SUNDRY NOTICES AND REPORTS ON WELLS

Proposed procedure to P&A:

Oreo "25" Federal Com No. 1

RE: Plugging and Abandonment Requirements, Conditions of Approval

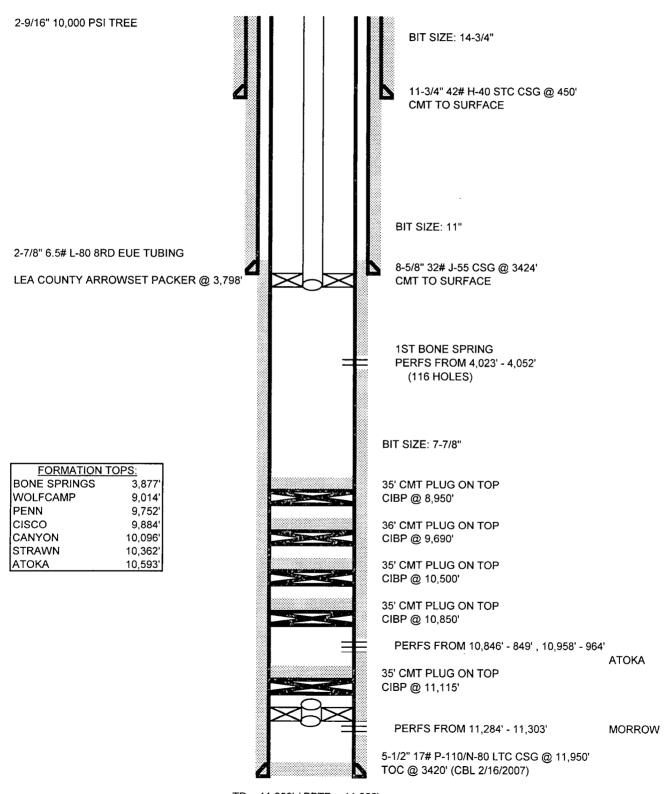
- 0. Tag to verify depth of CIBP and cement at 8915' or shallower.
- 0a. Spot a plug (minimum 25sx) from 5950'-5790'. (Spacer)
- 1. Move: CIBP to be set 50'-100' above top perf Otherwise OK (Perfs)
- 1a. Spot a plug (minimum 25sx) from 3925'-3785'. (Bone Spring)
- 2. OK
- 3. Spot from 3475' to 50' above the stub. Tag to verify 50' above stub Otherwise OK (Casing shoe Stub)
- 4. OK (Spacer)
- 5. Move: Spot plug from 1015'-905'. Tag at 905' or shallower Otherwise OK (Yates BOS)
- 6. OK (Casing shoe TOS Surface)
- 7. Verify that all annuluses have cement to surface and fill in as required Otherwise OK
- 8. Submit a subsequent report to the BLM.
